IN THE DRAWINGS

Please amend the drawings as follows:

The attached sheets of drawings, sheets 1 through 6, include amendments to FIGs. 2, 3, 4, 7, 8, and 9. These sheets replace the original sheets 1 through 6.

FIG. 2

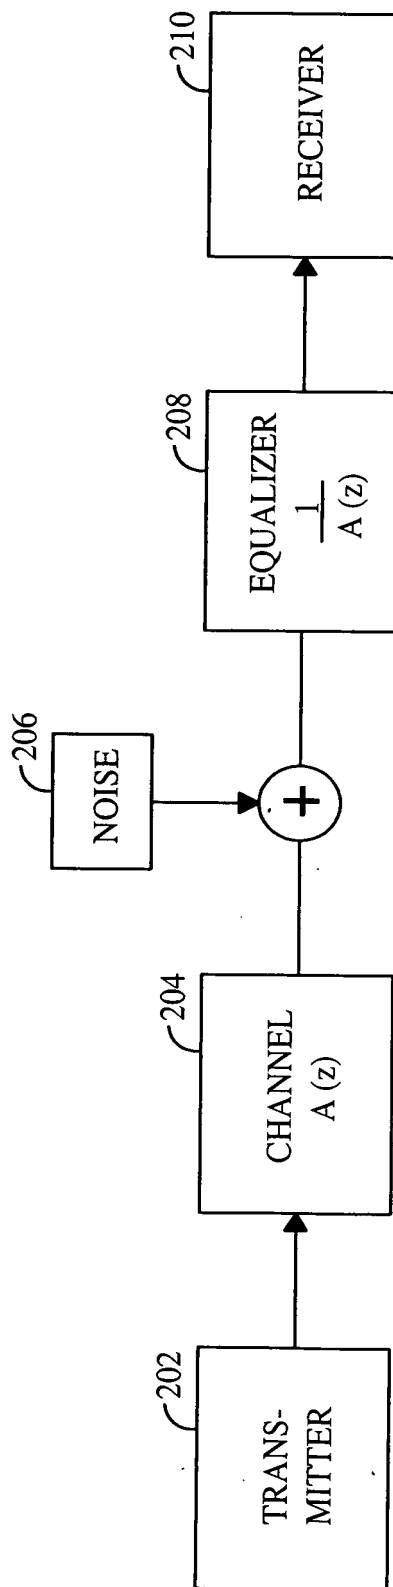
Specifically, Applicant amends FIGs. 2, 3, 4, and 9 to correct minor typographical errors. FIGs. 2, 3, and 9 have the argument of the function "A()" changed to the discrete complex variable "z" instead of the mistyped "2" in the original drawings. FIG. 9 also has the equalizer transfer functions corrected to be $H1(z)$ and $H2(z)$ consistent to the specification. FIG. 4 has the label added for communication system **400** consistent to paragraph [1028]. The name of element **412** in FIG. 4 was inadvertently omitted. This element has been labeled "controller." Paragraph [1035] in the specification as originally filed refers to "the controller **412**." Hence, this correction does not constitute new matter.

FIG. 7

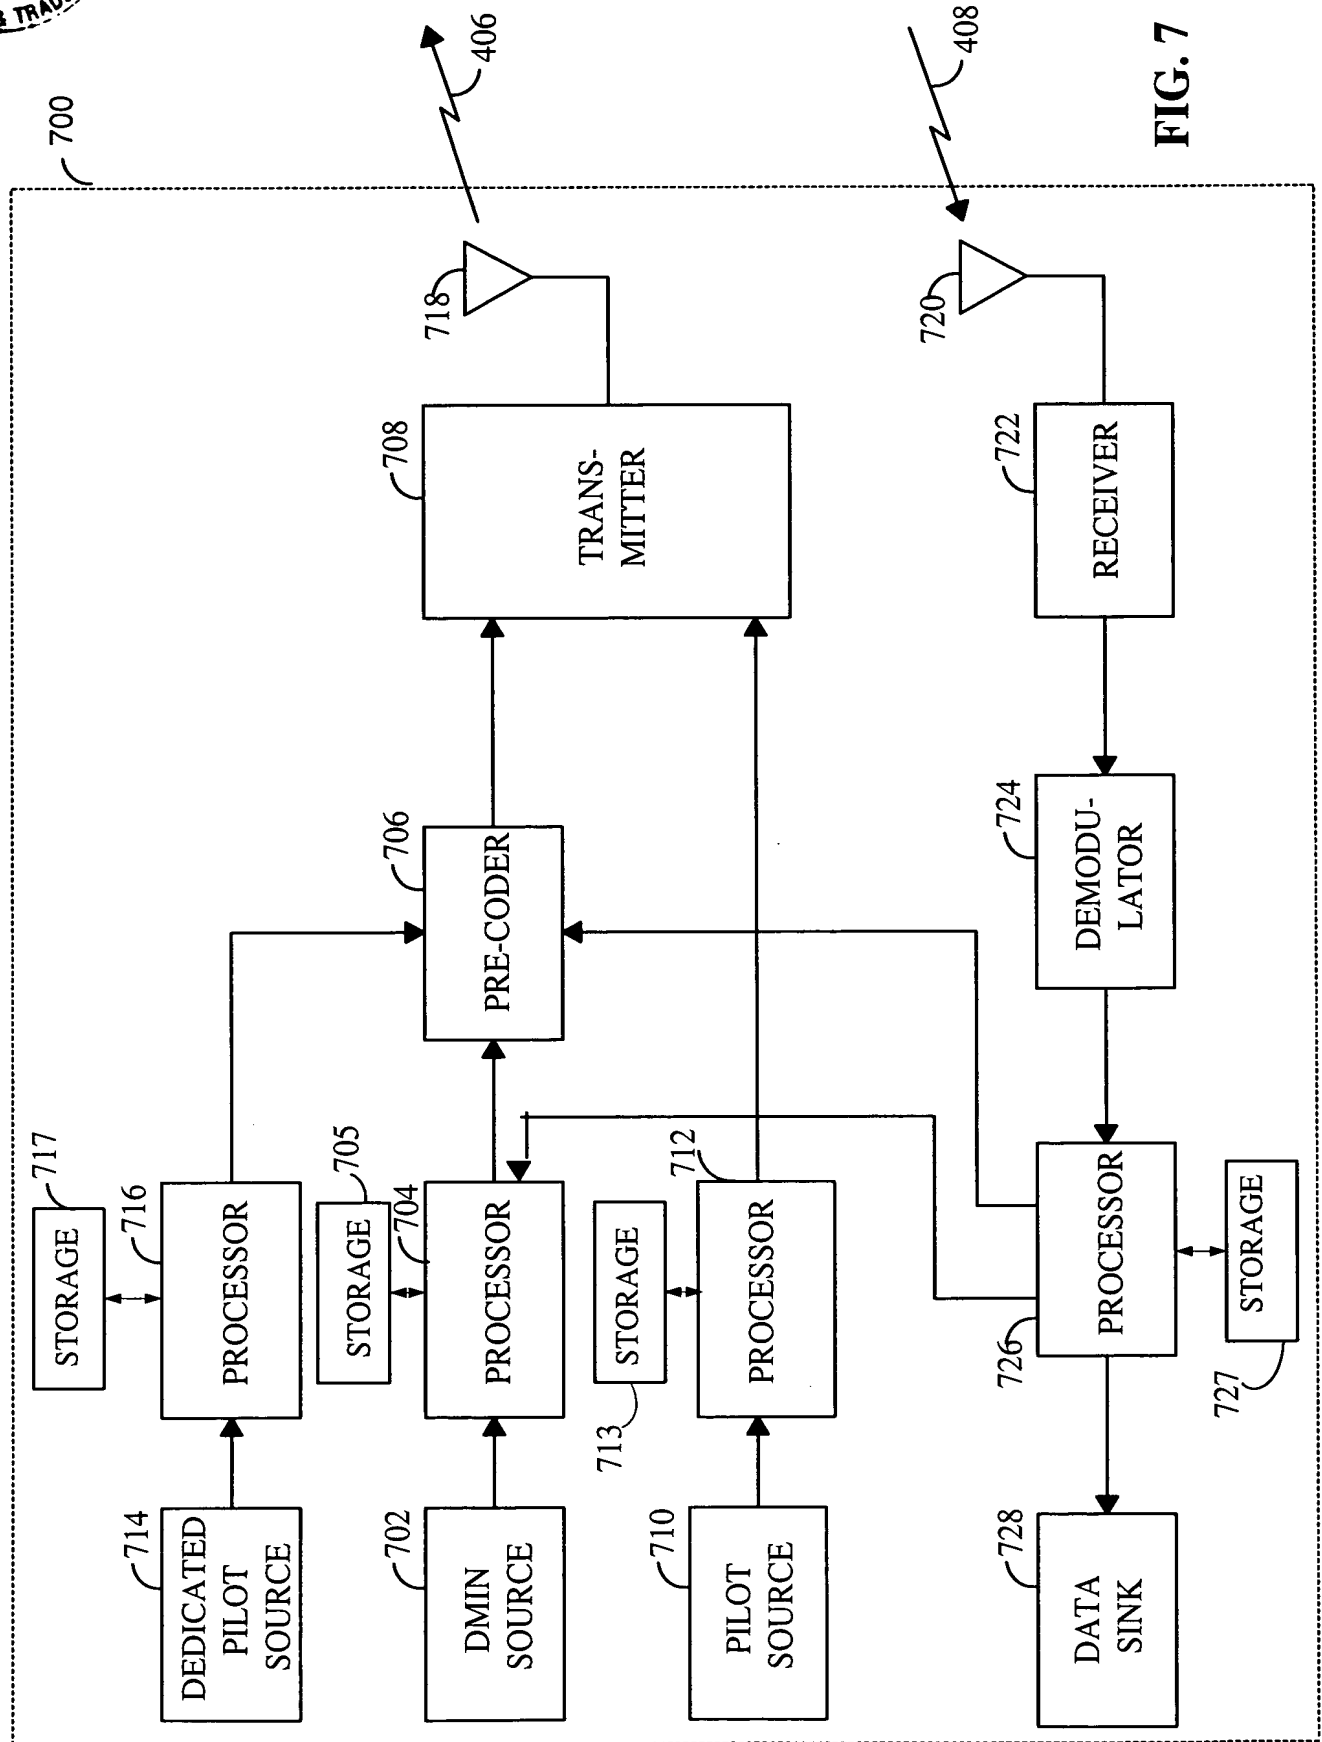
FIGs. 7 and 8 are amended to have storage attached to all processors to comply with examiner's objection that the drawings must show every feature of the invention specified in the claims. Applicant states that the addition is not new matter because digital processing and computation inherently involves some sort of storage, either separately or distributed among the processing elements, or both. Further paragraph [1059] in the original specification discusses various storages media that can be coupled to the processor.
